Comments on the Final EIR/EIS

**Cadiz Groundwater Storage Project  
Cadiz and Fenner Valleys  
San Bernardino County, California**

John Bredehoeft, Ph.D.  
October 2001

Figure 1. Scenario of annual pumping and storage.

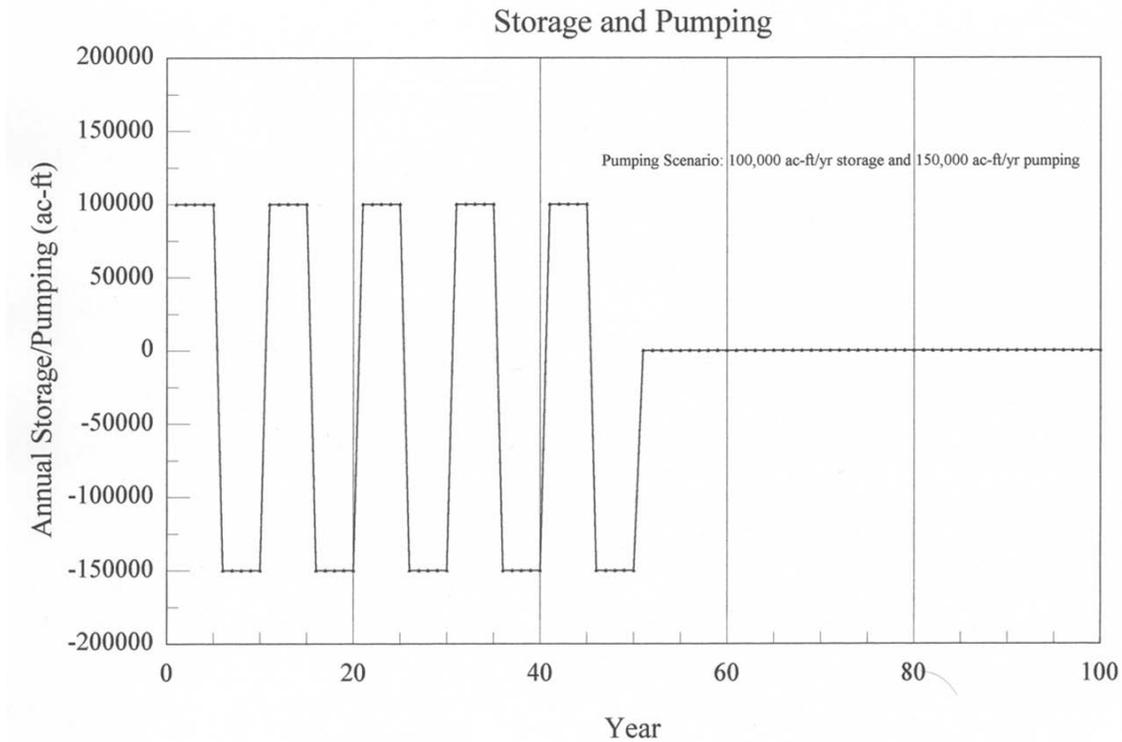
To make the analysis specific I assume five equal periods of storage (5 years each); each storage period is followed by an equal period of pumping (5 years each). During the storage period I assume 100,000 acre-feet is stored annually. During the pumping period I assume 150,000 acre-feet of groundwater is pumped annually. The scenario of storage and pumping is illustrated in Figure 1.

During the 50-year life of the project, as envisioned in the Figure 1 scenario, the operations result in:

Stored Water	2,500,000 acre-feet
Pumped Water	2,500,000 acre-feet of stored Colorado River Water 1,250,000 acre-feet of indigenous groundwater

Figure 3. Simulated change in TDS in well SCE 5.

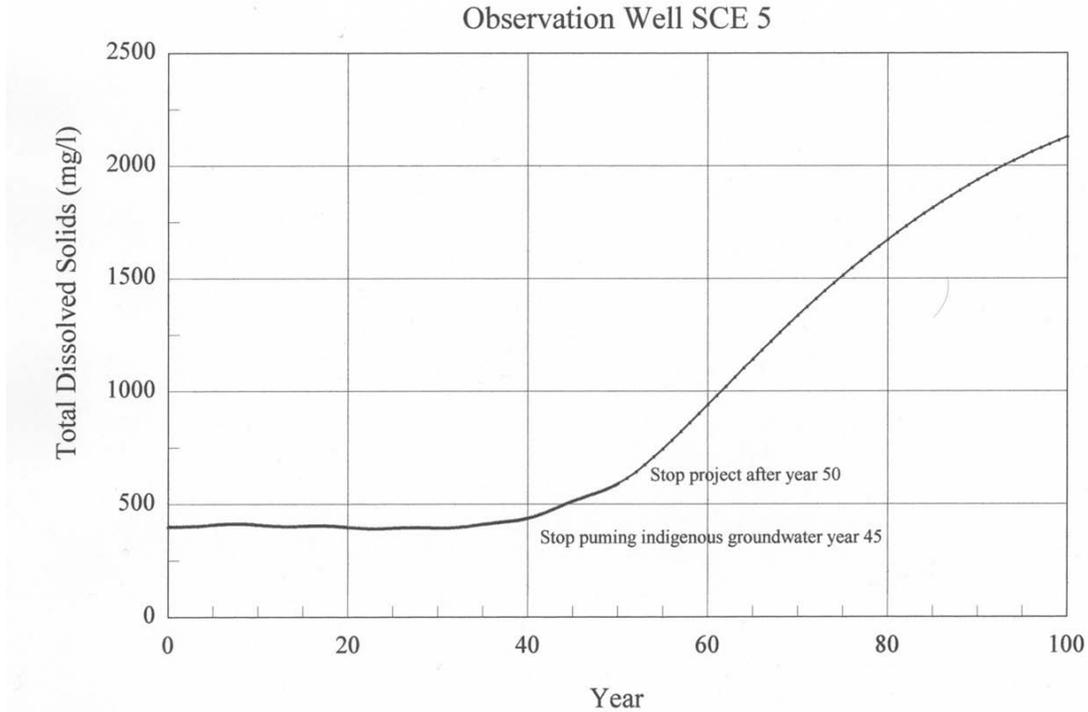
totally stopping the project after year 50. Nevertheless, the quality of water continues to deteriorate for the next 50 years after stopping the project—out to year 100, as far as the simulation was carried. The TDS exceeds 1000 mg/l in year 62. The increase in total dissolved solids is an indication that the salt water associated with Bristol Lake Playa is moving toward the area of pumping; it continues to move even though the project stops.

The simulated increase in total dissolved solids violates the water quality standards adopted by the State of California. The Basin Plan adopted by the California Regional Quality Control Board for the region has as its goal to maintain the existing water quality of all nondegraded groundwater basins. The State of California Department of Health Services has identified a secondary water quality standard of 1000 mg/l for TDS in drinking water.

The movement of salty water could be reversed by recharging water at the recharge facility. However, it would take a quantity of recharge approaching the magnitude of the total amount of local groundwater extracted in the 45 years of pumping (approximately 1 million acre-feet) to reverse the situation. This amount of recharge is outside the realm of feasibility.

Figure 4. Simulated TDS in two observation wells near Bristol Lake Playa.

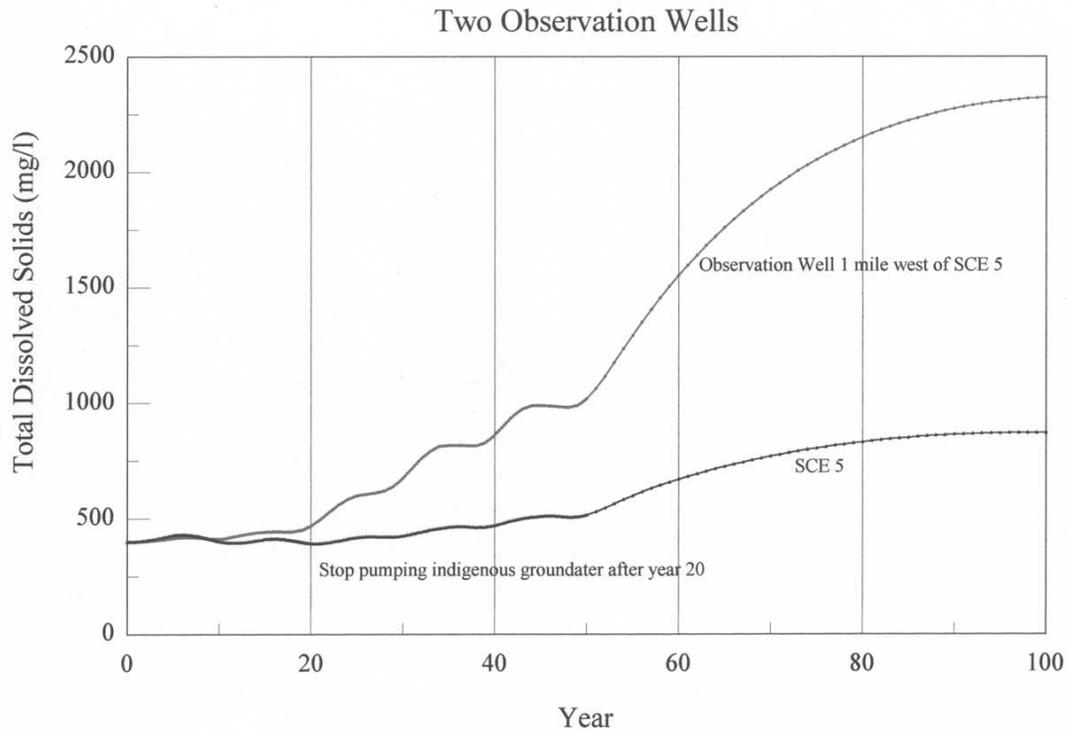
The Management Plan proposes that a set of observation wells be drilled between well SCE 5 and Bristol Lake Playa. I have simulated the changes in water quality at a well 1 mile west of SCE 5, closer to the Bristol Lake Playa. Figure 4 is a simulated plot of TDS in this hypothetical well. The criterion for triggering action, a change in water quality of

more than 25%, is met approximately in year 20. I simulated stopping the extraction of indigenous groundwater after year 20; from that time through year 50 only storage and extraction of Colorado River water is simulated.

Again, stopping the pumping of indigenous groundwater does not stop the degradation in water quality. At this location the deterioration continues to year 100. The TDS at year 100 exceeds 2000 mg/l. This scenario also increases the TDS level at well SCE 5 to approximately 800 mg/l.

Figure 5. Simulated drawdown in an observation well near Danby.

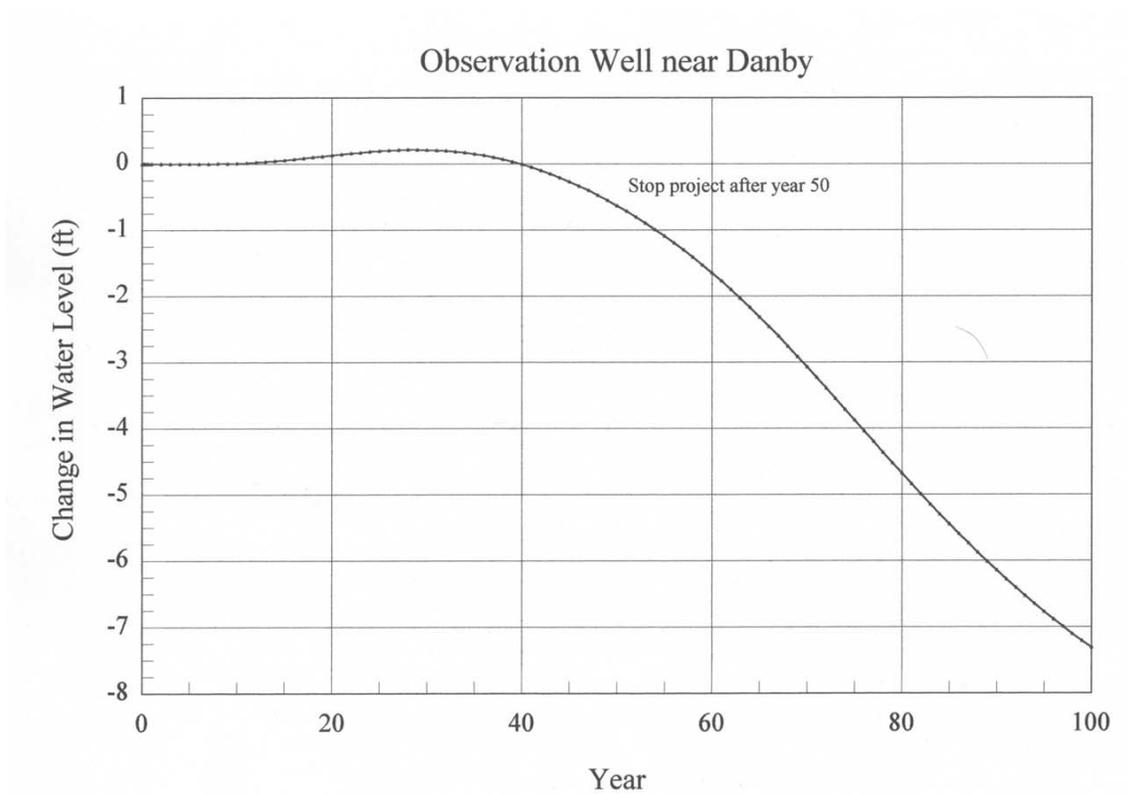
Figure 5 is the simulated plot of the water level change in the well at Danby. In this instance the change in water level only exceeds the trigger criterion of a 1-foot change in approximately year 54; the project was stopped after year 50. However this is only the beginning of the change; the water level continues to steadily decline to year 100.

The point of this illustration is that it takes more than 50 years for the change in water level to exceed 1 foot, but the decline continues to more than 7 feet in 100 years even though the project was totally stopped. If we wanted to avoid the decline in water level at Danby we would have to halt the project, or at least halt the extraction of indigenous groundwater, long before the water-level change there reached 1 foot. One could imagine adverse impacts to springs in the nearby mountains long after the project was stopped.
